Value Engineering Study

VE# 201106

US 150 from KY49 to Leslie Ballard Road

Item Numbers 4-8308 and 4-8309

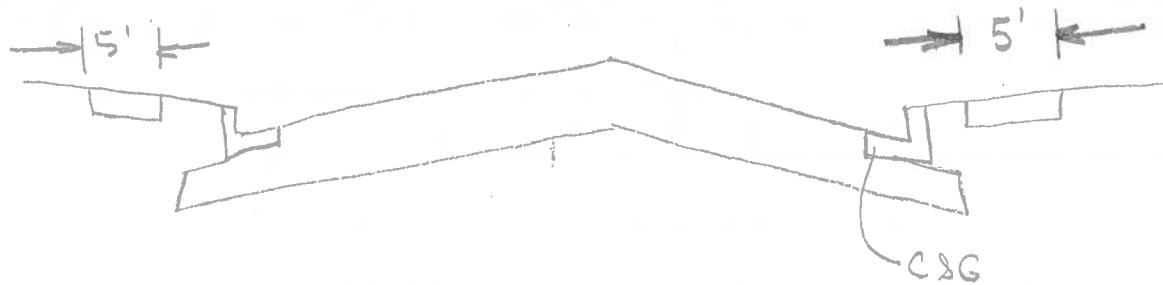
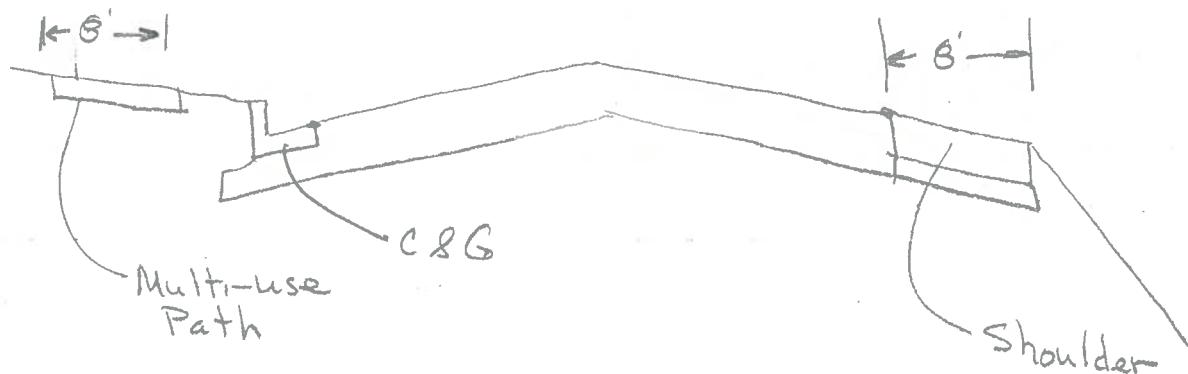
The original design calls for a sidewalk to end ~~at~~ north of Filiatreau Lane. There is no planned sidewalk south of Filiatreau Lane.
